5343A-31C-S

S E R V I C E N O T E

HP 5343A Microwave Frequency Counter

Support Strut for the HP 5343A Microwave Frequency Counter

Figure 1. HP 5342A/43A/44A Orientation and Support Strut Installation

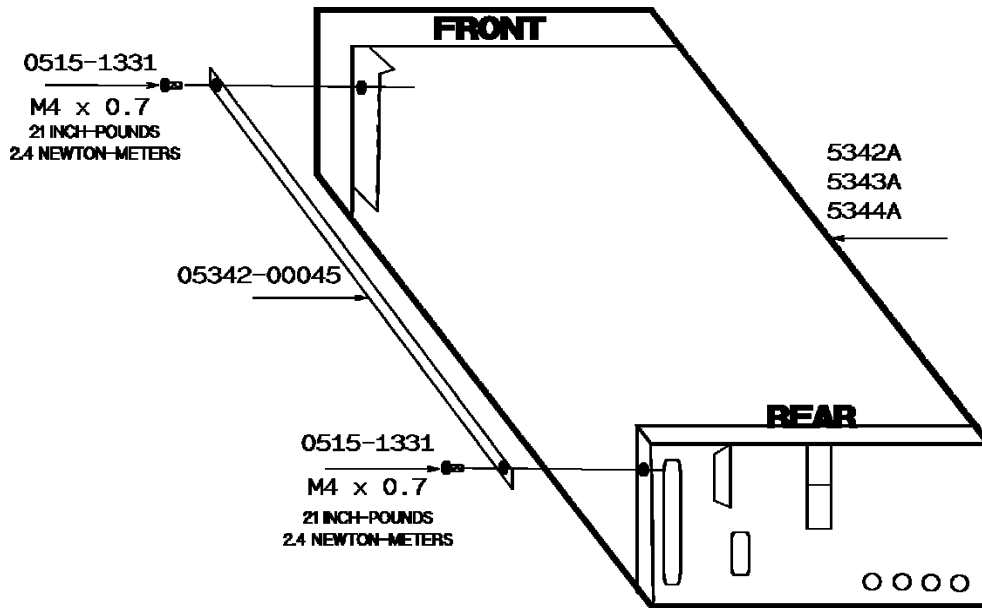
The cabinet framework of HP 5342A/43A/44A Microwave Frequency Counters and HP 5344A Microwave Source Synchronizers with serial prefix 2636A and below does not ensure that the front and rear castings will remain in parallelism. When the front and rear castings are out of parallelism, it creates a condition where the top cover may not be fully captured, and could work loose upon application of an added force. Since the carrying handle is attached to the top cover, the unit could fall if it is lifted by the handle.

Installing a support strut eliminates this potential safety problem.

1. At top rear of HP 5342A/43A/44A, remove pozidrive screw from rear cap retainer and remove retainer.
2. Slide top cover back until free from frame and lift off.
3. Attach support strut, P/N 05342-00045, to the top left side of the cabinet framework with two metric screws, P/N 0515-1331. See Figure 1 for proper orientation of the HP 5342A/43A/44A.

Appropriate screw holes are already drilled in cabinet framework. Do not attempt to drill additional holes.
